**STRATFORD PROPERTIES LTD - PRIVATE PLAN CHANGE REQUEST – RESPONSE TO CLAUSE 23 RMA FURTHER INFORMATION REQUEST**

Please find below our response to the request for further information dated 20<sup>th</sup> January 2020 in respect to the above private plan change request. This response has been prepared with specialist technical inputs by the consultant team as follows:

**Figure 1 – Extent of Flood Plain in Surrounding Area**

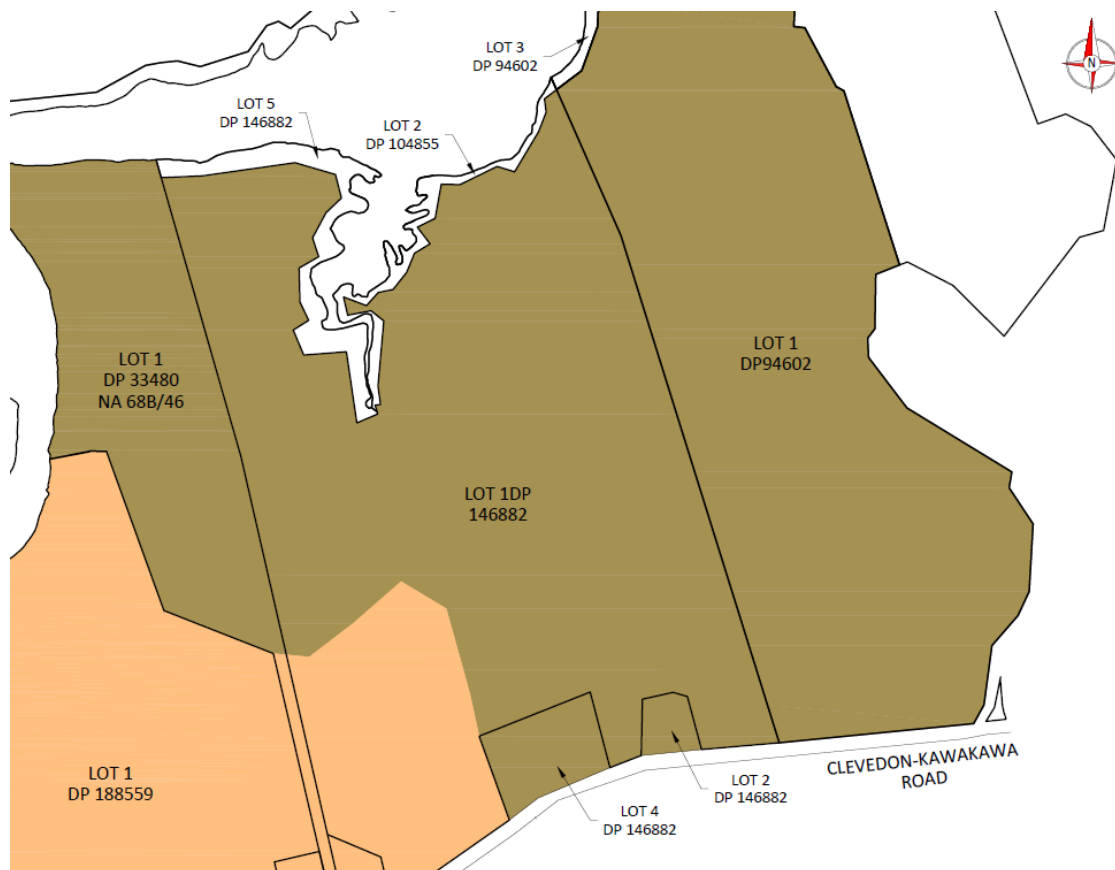
**P2 – Defensible Boundary**

As can be seen on **Figure 1** below, the 1% AEP flood plain and the associated *Coastal Inundation 1 per cent Annual Exceedance Probability Plus 1m Control – 1m sea level rise control* will also limit the opportunity for countryside living development (i.e. dwellings) to occur beyond the eastern boundary of 278 Clevedon-Kawakawa Road. The closest land outside of the flood plain to the east that could potentially be developed for similar land uses is the property at 410 Clevedon-Kawakawa Road, which is located some 1.1 km from the area outside of the flood plain that is available for development on the plan change site.

There is a small area at the frontage of the adjacent property at 340 Clevedon-Kawakawa Road that contains the existing farm dwellings and associated buildings. This area is less than the 6,000m<sup>2</sup> maximum site size for Clevedon Sub Precinct C. As such, given the flood plain extends over the remainder of this property, there could be no additional development rights created by extending the Rural – Countryside Living Zone and Clevedon – Sub-precinct C over the adjacent property at 340 Clevedon-Kawakawa Road. It is therefore highly improbable that the landowner would seek to rezone this land in the future.

This means the requested extension of the Rural – Countryside Living Zone and Clevedon – Sub-precinct C over the properties at 274 and 278 Clevedon-Kawakawa Road would not be continued in the future over to the adjacent property to the east at 340 Clevedon-Kawakawa
